CONWAY
HISTORIC DISTRICT COMMISSION
STAFF REPORT

5:30 pm • October 28, 2019 • City Hall

I.A MOFFETT HOUSE EXTERIOR MODIFICATIONS - 1616 ROBINSON AVENUE

II.A NEW SINGLE-FAMILY RESIDENCE - 2030 DUNCAN STREET

1 NORTH ELEVATION
1/8" = 1'-0"

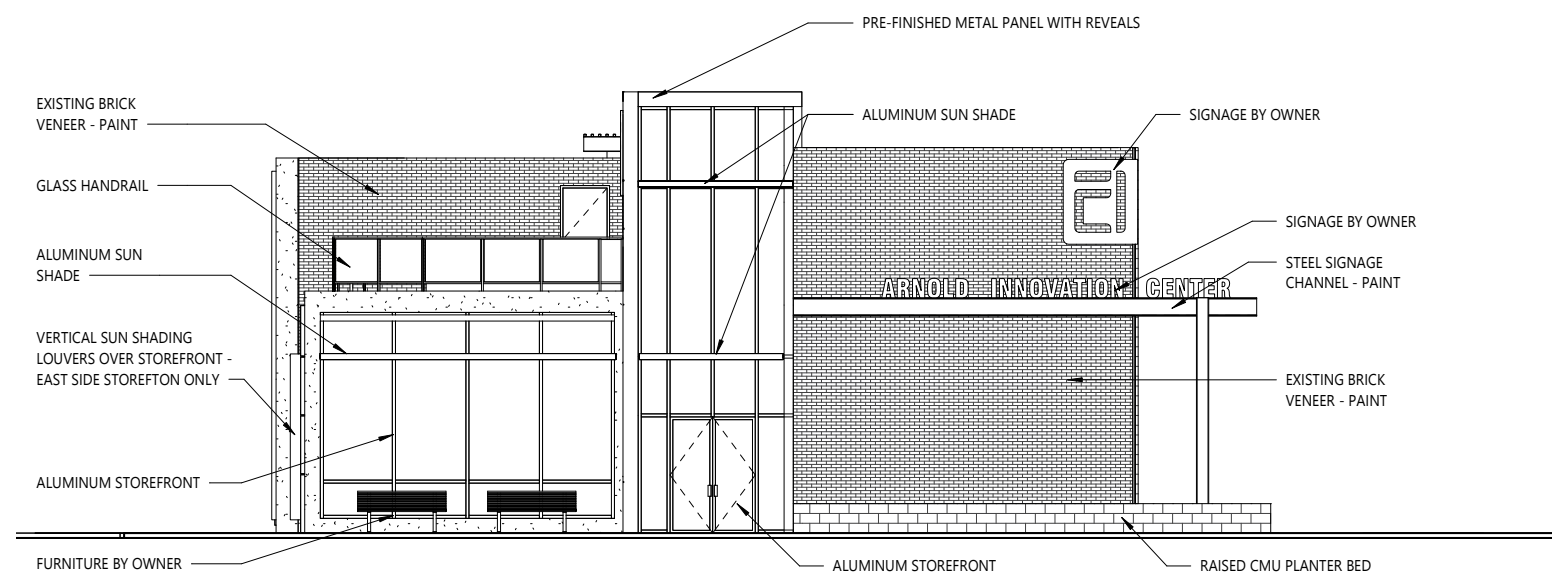
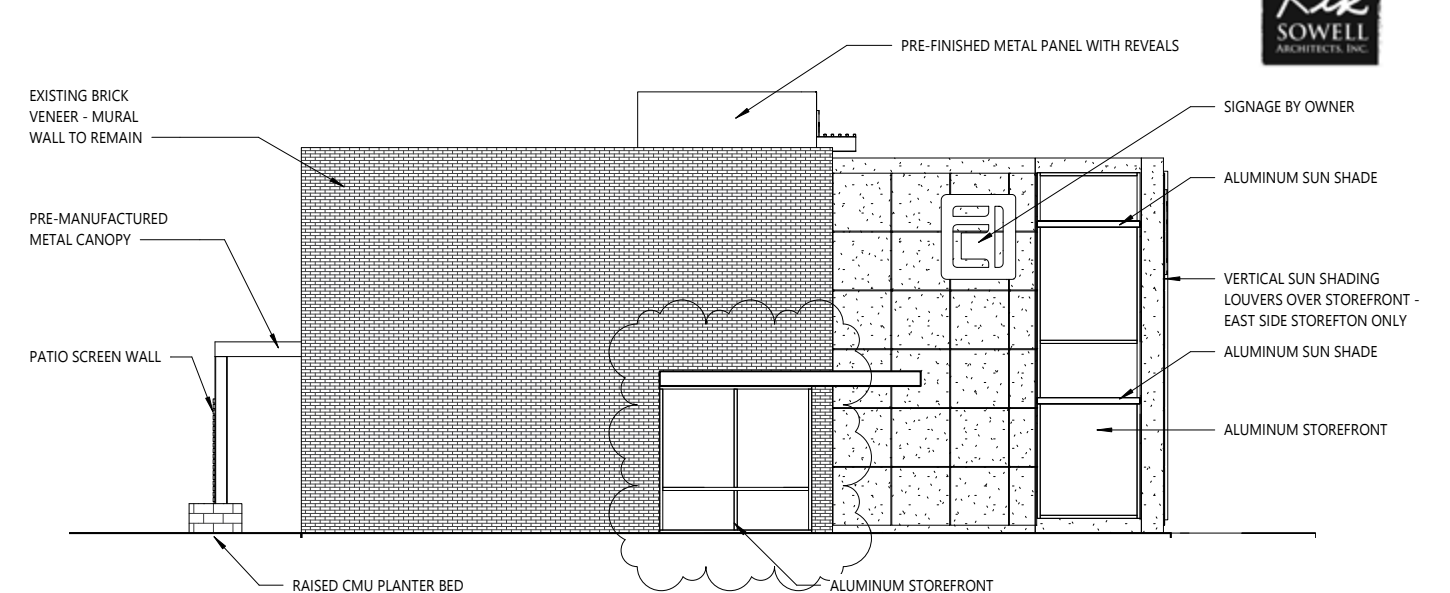
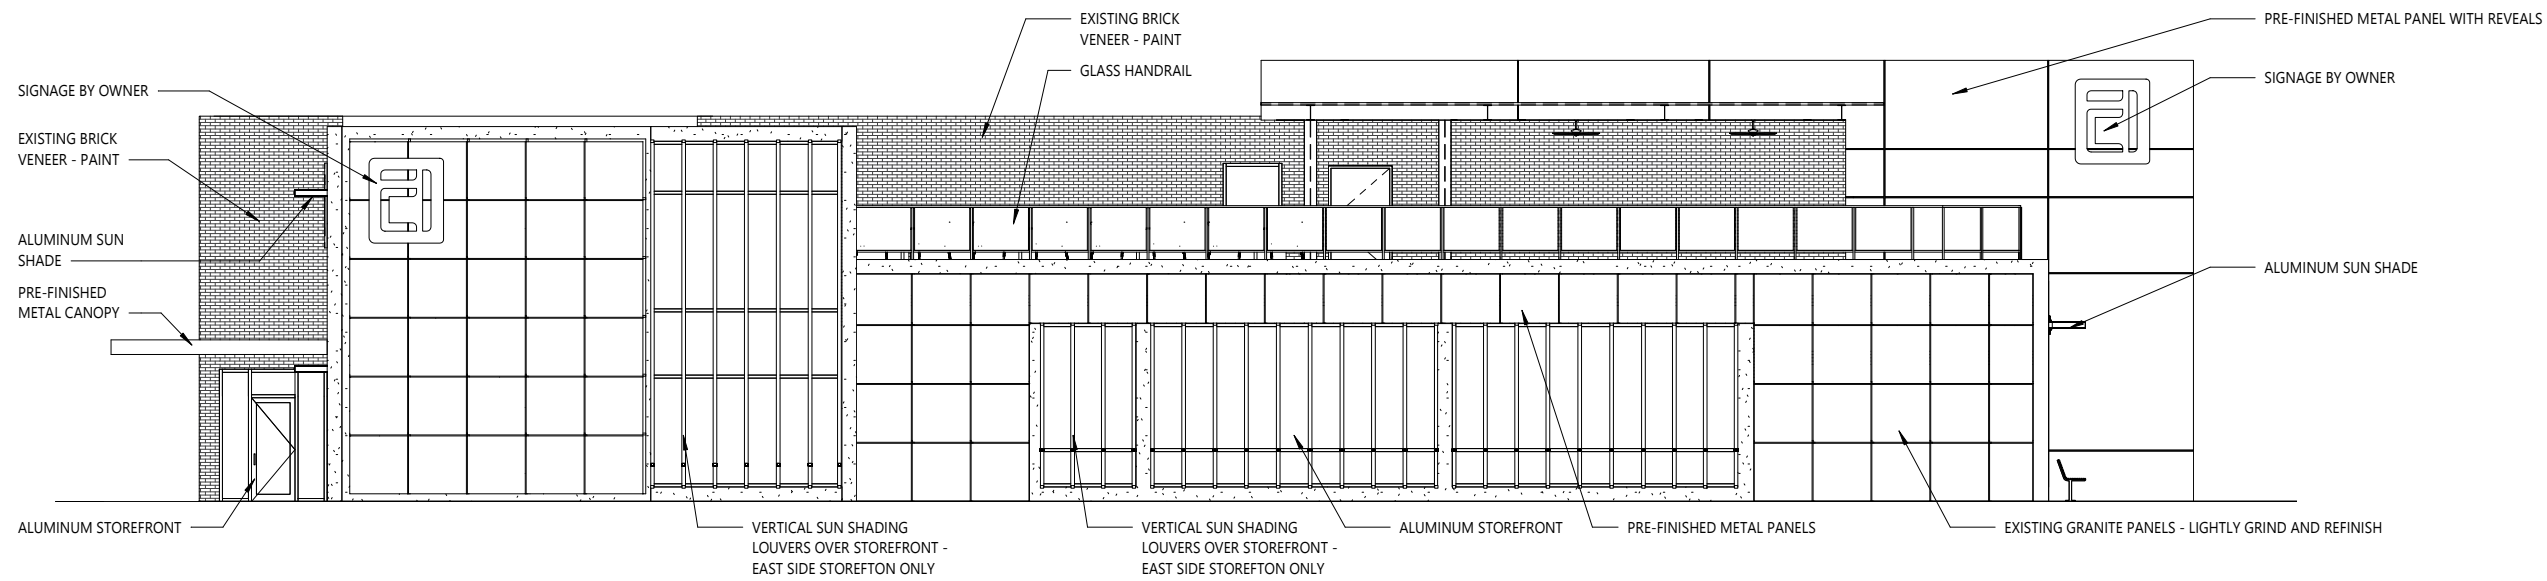
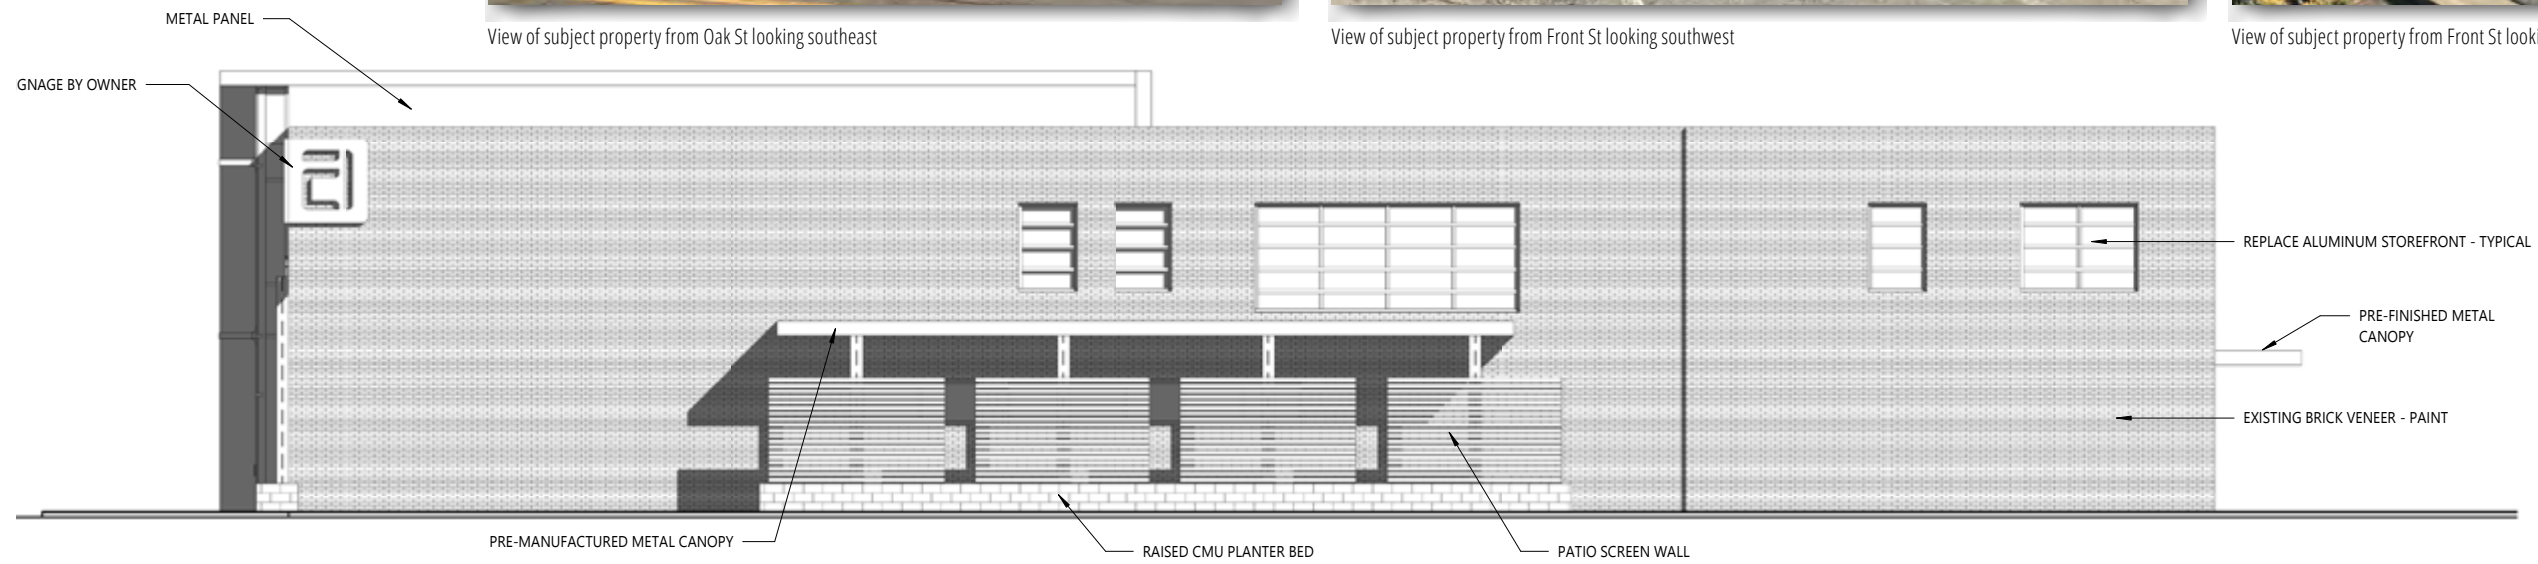
All existing window openings shall be maintained to preserve some of the appearance of the original structure. The building will have more than adequate articulation.

All existing window openings on the ground-level shall be maintained. The entry shall have additional glazing to add to the monumental character of the building.

Non-tinted, non-transparent glass shall not be permitted. All building materials proposed by the applicant are appropriate. Recommend requiring existing brick to remain unpainted.

The front entrance shall be located at the street and feature a large glass atrium that will give the building a monumental character.

1. Provide plans and coordinate with the City of Conway to address the existing parking lot, required parking screening, dumpster enclosure, site access, landscaping (including CMU material used for planters), and front plaza design.
2. Provide plans for external lighting of the facility.
3. New windows shall be non-tinted.
4. Existing unpainted brick shall remain unpainted.
5. HVAC equipment be placed in a manner to minimize its visibility from the street.

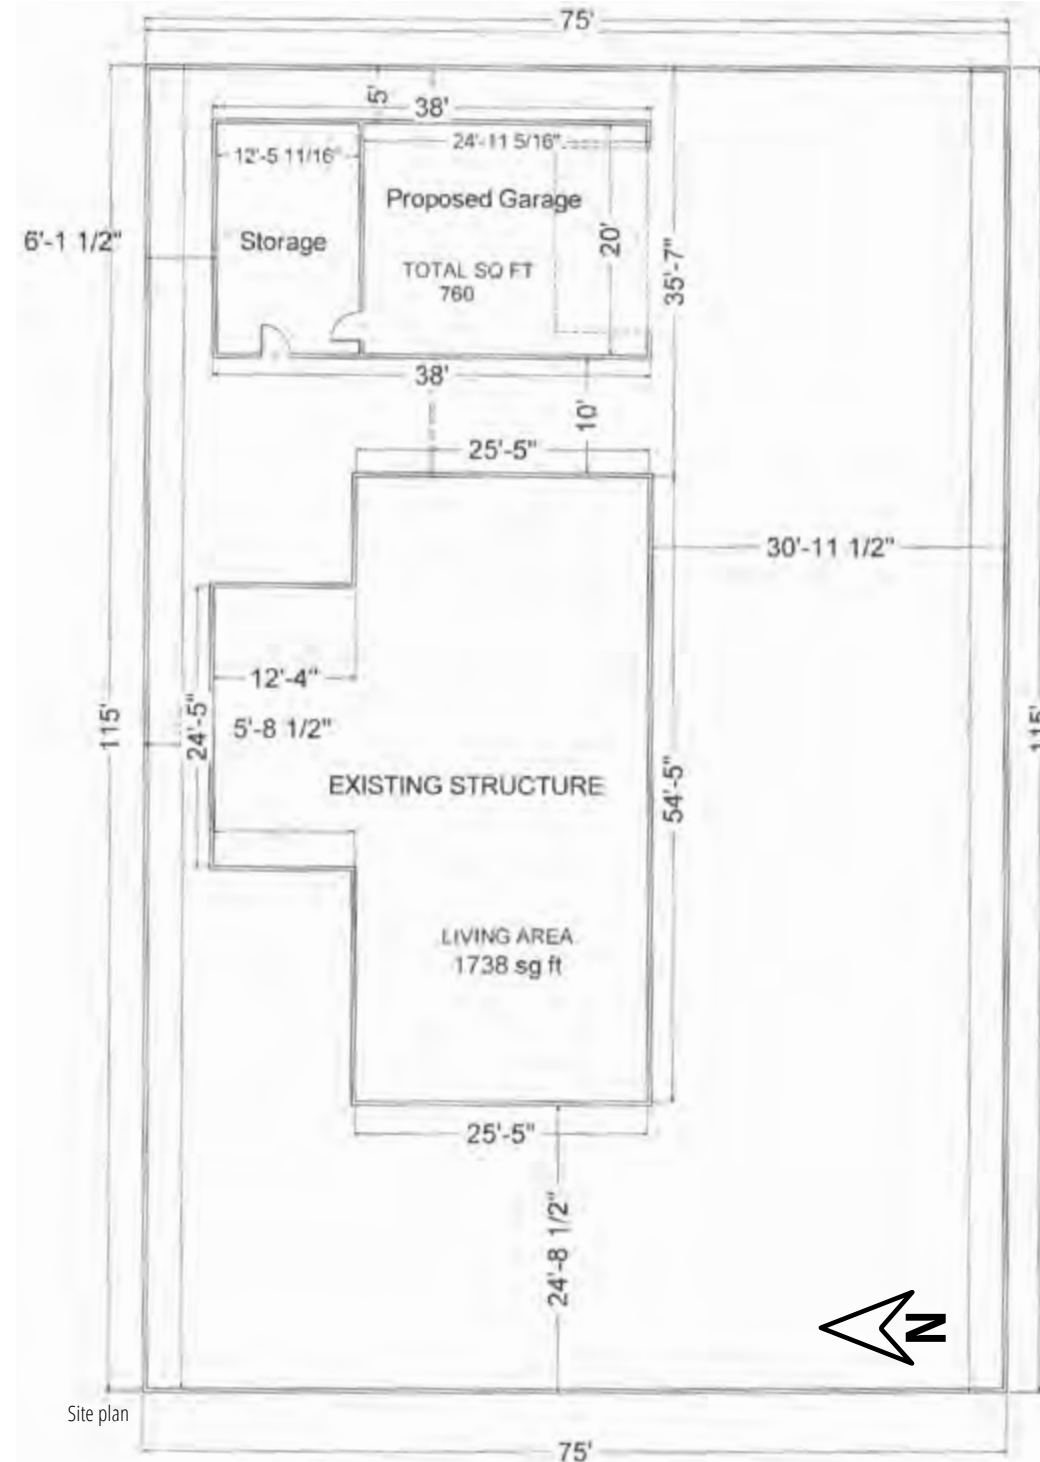
As proposed, the setbacks will be 5' to the rear, 6' from the interior side, and 30' to the secondary frontage. The garage will be placed to the rear of structure when viewed from the primary frontage.

The structure will feature a hip roof that is compatible in design and pitch to the roof of the primary structure.

The plans submitted for review do not indicate a proposed material. It appears the existing house is clad in vinyl siding, however the use of vinyl siding for new construction in the Overlay District is not appropriate. The applicant shall clad the proposed structure in an appropriate material including wood siding or cement fiber siding (Hardie board).

The proposed area of the accessory structures on the site exceeds the allowable 30% area for accessory structures. The applicant shall reduce the size of the structure to meet the requirement. Alternatively, the applicant may connect the proposed accessory structure to the primary structure using a breezeway or another type of connecting feature.

1. The proposed accessory structure shall be clad in either wood siding or cement fiber siding (Hardie Board).
2. The applicant shall reduce the size of the structure to meet the requirement or connect the proposed accessory structure to the primary structure using a breezeway or another type of connecting feature.
